Possum Kingdom IF- ADA Evaluation

Accessibility Evaluation

Inspection Date: 03/22/2023

Report Date: 02/05/2024

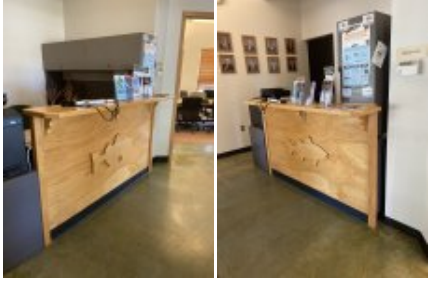
9	Exterior of Property (Public): Water Treatment Building (Exterior) - TOUR	The building entrance is not located on an accessible route. When a building, or portion of a building, is required to be accessible, an accessible route of travel shall be provided to all portions of the building, to accessible building entrances and between the building and the public way. At least one accessible route within the boundary of the site must be provided from public transportation stops, accessible parking and accessible passenger loading zones and public streets or sidewalks to the accessible building entrance they serve. The accessible route shall, to the maximum extent feasible, coincide with the route for the general public. At least one accessible route shall connect accessible buildings, facilities, elements and spaces that are on the same site. At least one accessible route shall connect accessible building or facility entrances with all accessible spaces and elements.	This building is not accessible.	https://www.access-board.gov/ada/#ada-206_2_1	2012 TAS Section: 206.2.1 2010 ADAS Section: 206.2.1 2015 ABAAS Section: F206.2.1

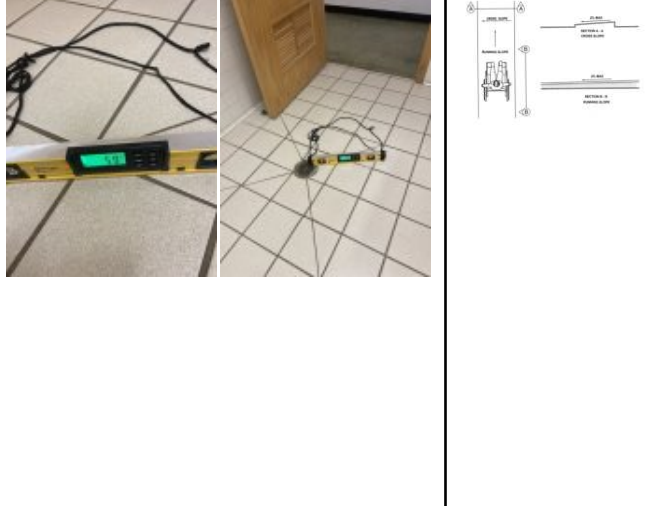
17	Structures on Property (Public) - Tour/Public Componets : HQ Building/Public Restrooms (Interior) - Restroom (Men's) Public/Staff	The floor drain is set too low in the floor which causes a slope over 2 percent. Changes in level are not permitted in clear floor or ground spaces or surfaces of a turning spaces and shall not slope greater than 1:48.	Significant drain slope, measured at 7.5%	https://www.access-board.gov/ada/#ada-303_3 https://www.access-board.gov/ada/#ada-304_2	2012 TAS Section: 303.3, 304.2, 304.2 Exception 2010 ADAS Section: 303.3, 304.2, 304.2 Exception 2015 ABAAS Section: 303.3, 304.2, 304.2 EXCEPTION, 305.2 EXCEPTION

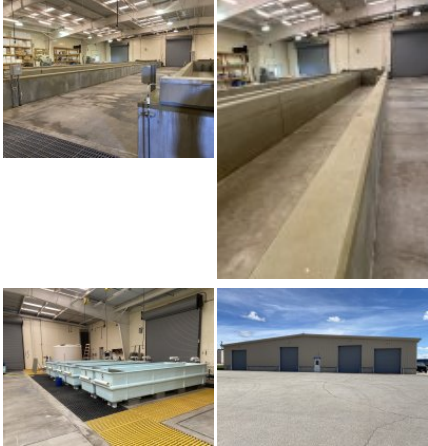
Finding Number	Area Description	Finding	As Built	Recommendation	Citation	Photos	Figure
18	Structures on Property (Public) - Tour/Public Componets : HQ Building/Public Restrooms (Interior) - Restroom (Men's) Public/Staff	The paper towel dispenser's operation mechanism is too high off the floor. Dispensers must have all operable parts a maximum of 48 inches above the floor.	Paper towel dispenser and light switch out of reach range, both over 48"	https://www.access-board.gov/ada/#ada-308_2_1	2012 TAS Section: 308.2.1 2010 ADAS Section: 308.2.1 2015 ABAAS Section: 308.2.1	 	
19	Structures on Property (Public) - Tour/Public Componets : HQ Building/Public Restrooms (Interior) - Restroom (Men's) Public/Staff	The water and drain pipes under the lavatory are not adequately insulated. Water supply and drain pipes under lavatories and sinks shall be insulated or otherwise configured to protect against contact. There shall be no sharp or abrasive surfaces under lavatories and sinks.	Pipes are exposed	https://www.access-board.gov/ada/#ada-606_5	2012 TAS Section: 606.5 2010 ADAS Section: 606.5 2015 ABAAS Section: 606.5

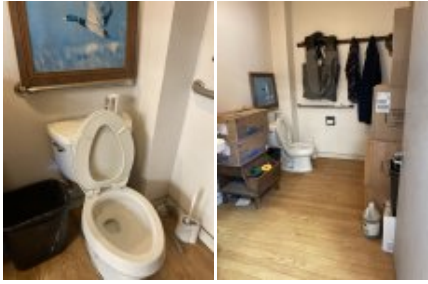
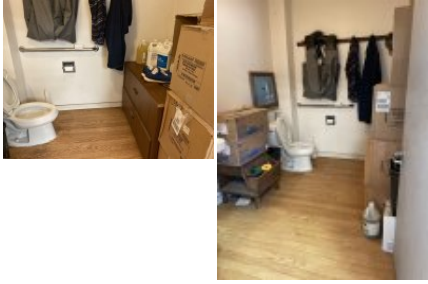
Finding Number	Area Description	Finding	As Built	Recommendation	Citation	Photos	Figure
32	Outdoor Features (Public) : Brazos River Nature Trail	The trailhead sign is missing the trail information. Trail information signs at trailheads shall include the following: 1. Length of the trail or trail segment; 2. Surface type; 3. Typical and minimum tread width; 4. Typical and maximum running slope; and 5. Typical and maximum cross slope.	Trail head sign is not compliant. Trail is overseen and maintained by TPWD personnel. Trail features some accessible componets including width and trail surface for limited distance.	N/A - Refer to Finding	2015 ABAAS Section: 1017.10
